Addendum No. 03

June 9, 2026

Parlier HS Stadium Replacement

PBK PROJECT NO.: 250093
DSA FILE NO.: 10-H12
DSA APPLICATION NO.: 02-124002 _ PARLIER HS STADIUM REPLACEMENT

Drawing: P:\224\224-0404\Site\ProductionDrawings\224404_UTPP01.dwg; C2 - BCF.ctb
Plot by: sduncan Jun 05, 2026 - 5:11pm

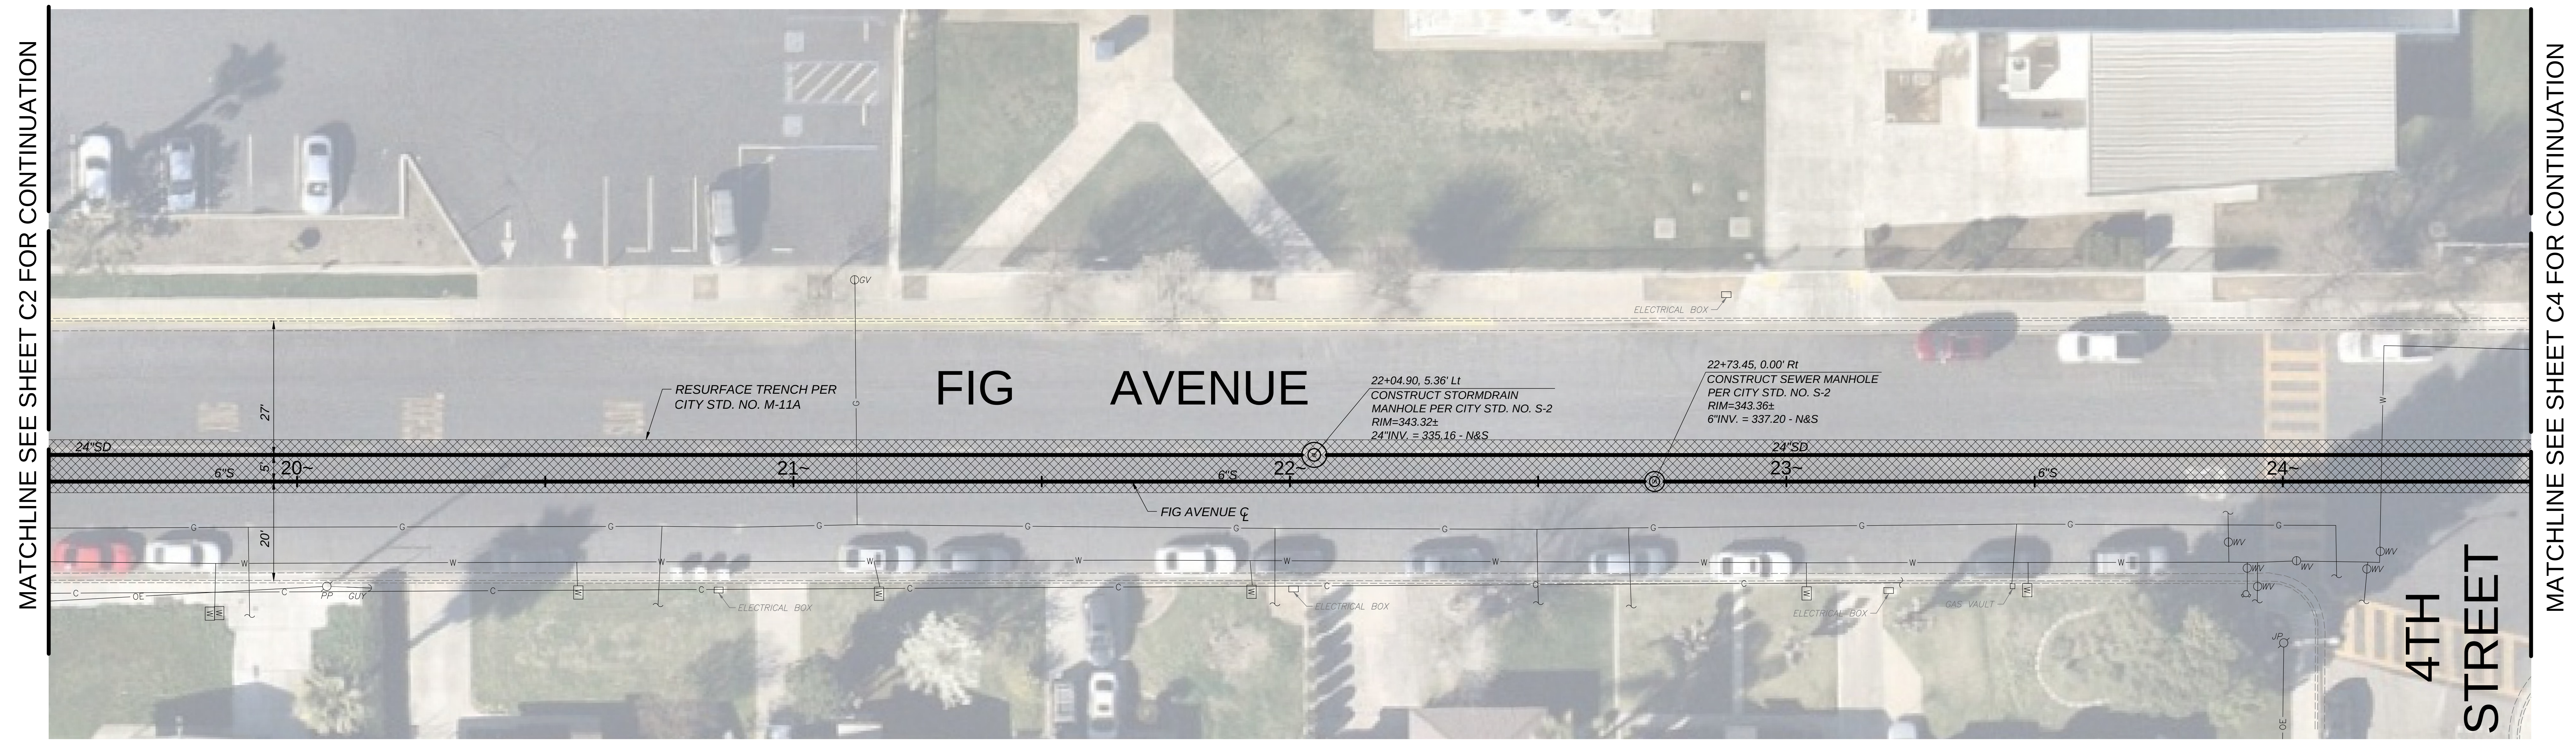
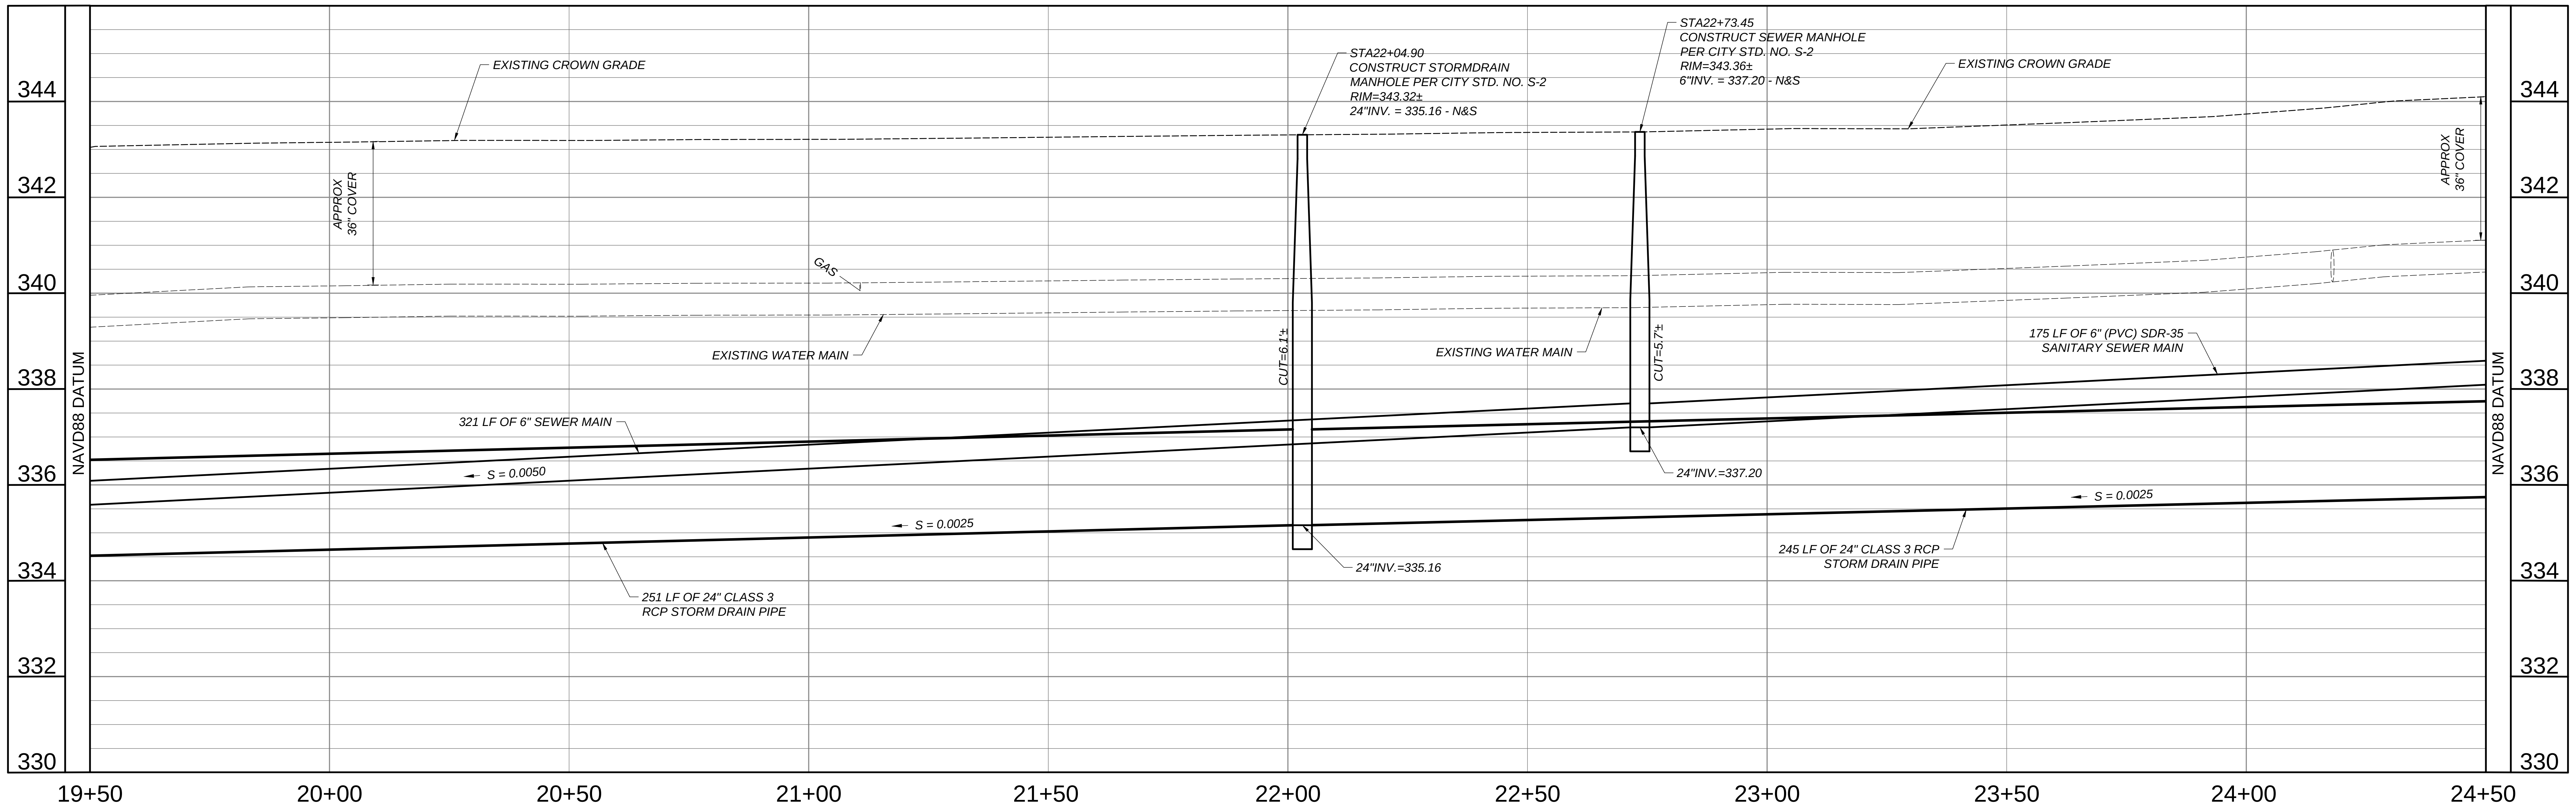
10. Refer to herein attached sheets C1-C4 “SEWER AND STORM DRAIN PLAN AND PROFILE”, identitified with AD3 on the bottom right-hand corner.
    a. Add attached sheets to the end of Sheet Section “CIVIL: SITE DEVELOPMENT.”

- Added plan and profile off site plans for sewer and storm drain.

PARTIAL PLANTING PLAN
LS2.2

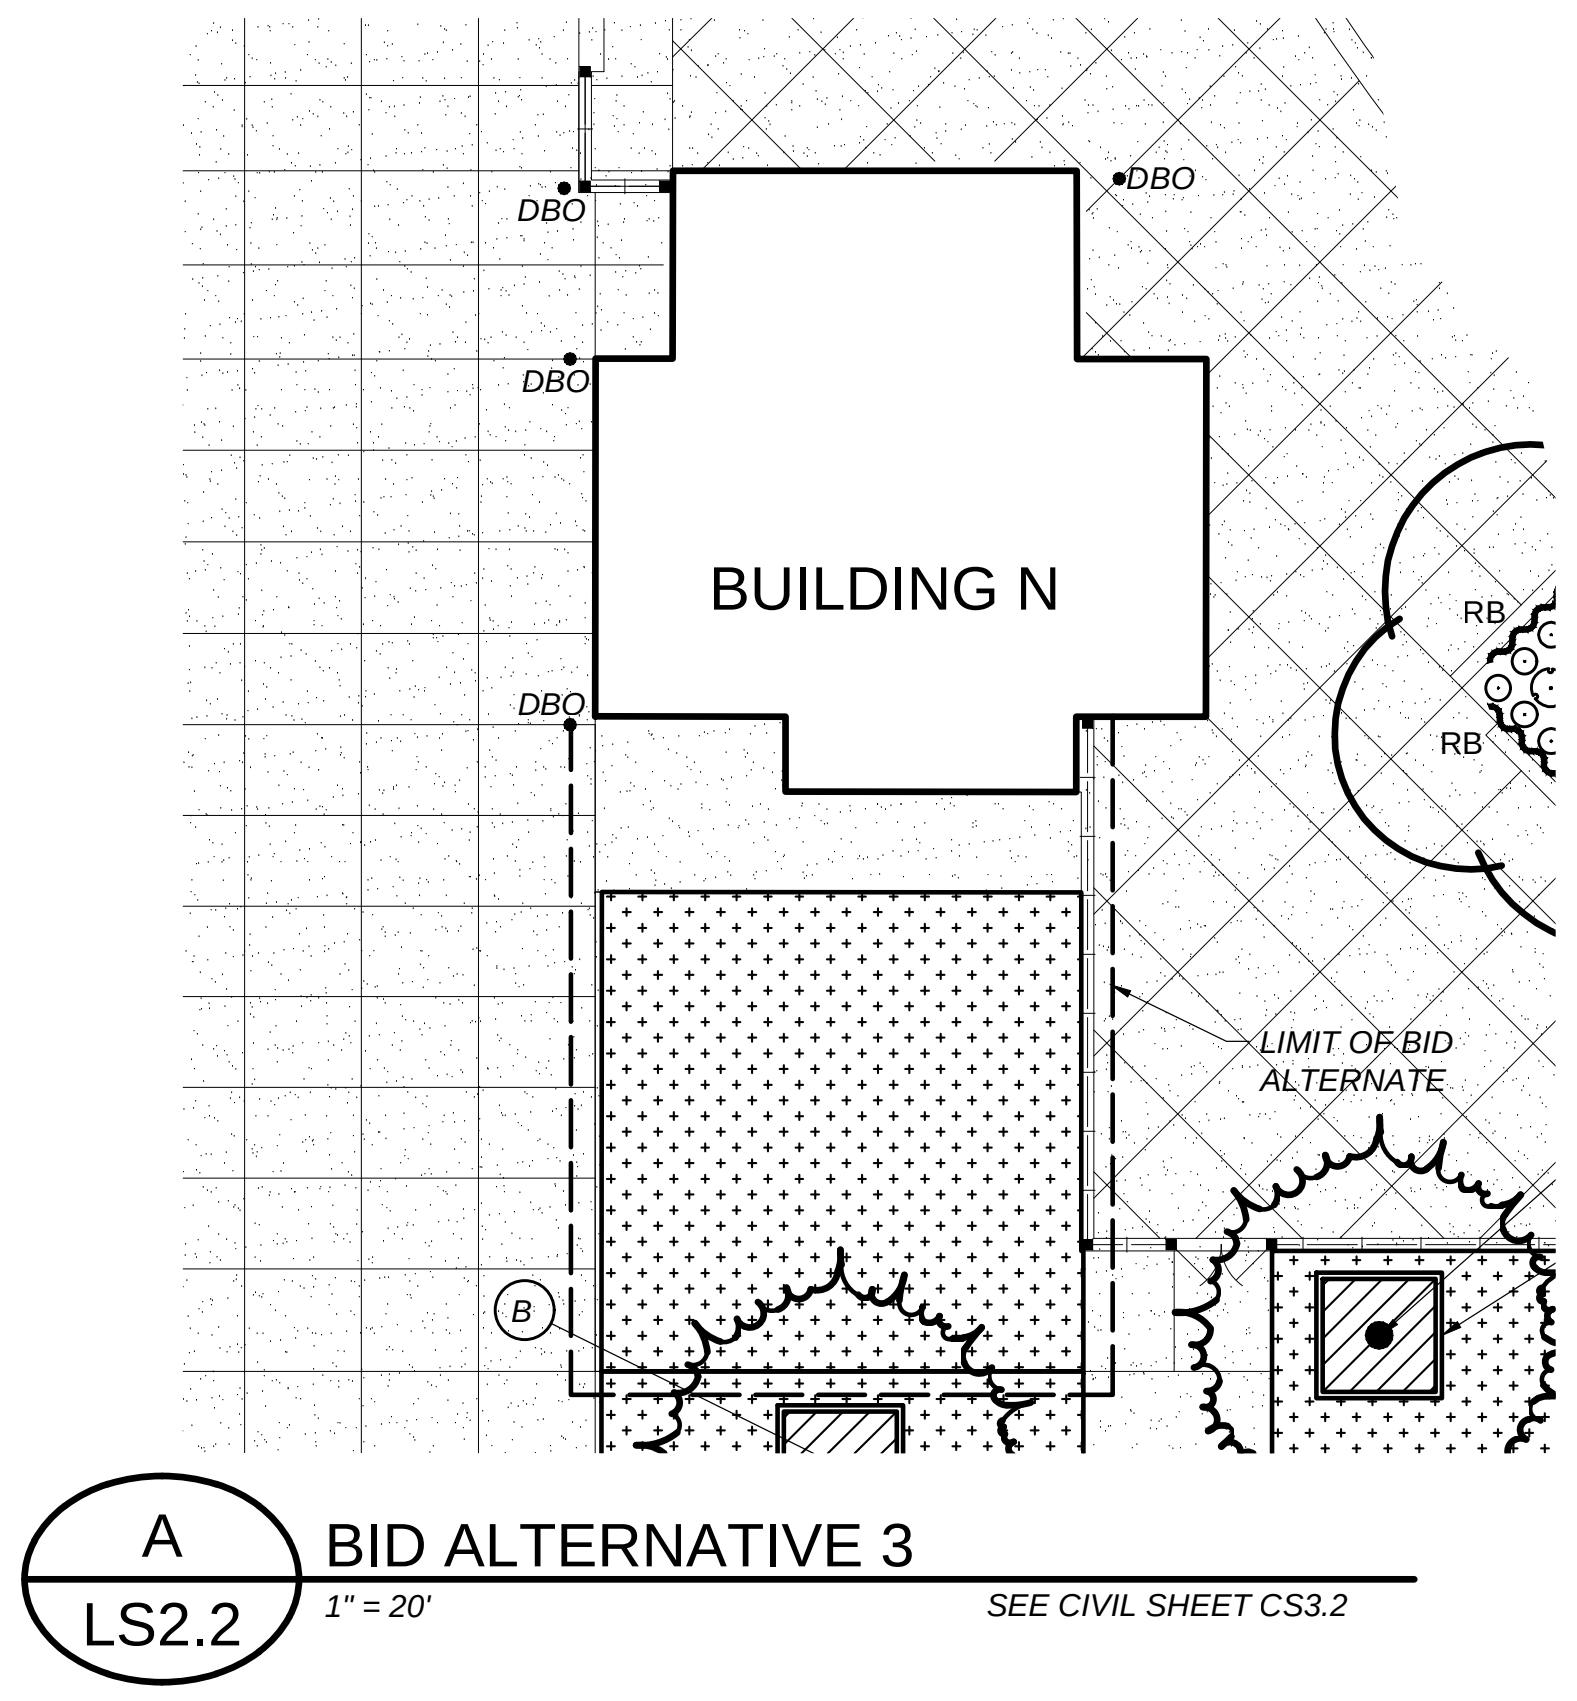
3. Refer to sheet LS2.2 “PARTIAL PLANTING PLAN”
    a. Remove and replace sheet LS2.2 “PARTIAL PLANTING PLAN” with herein attached sheet LS2.2 “PARTIAL PLANTING PLAN” identified with AD3 on the bottom right-hand corner.

- Revised planting per Site Plan revisions.
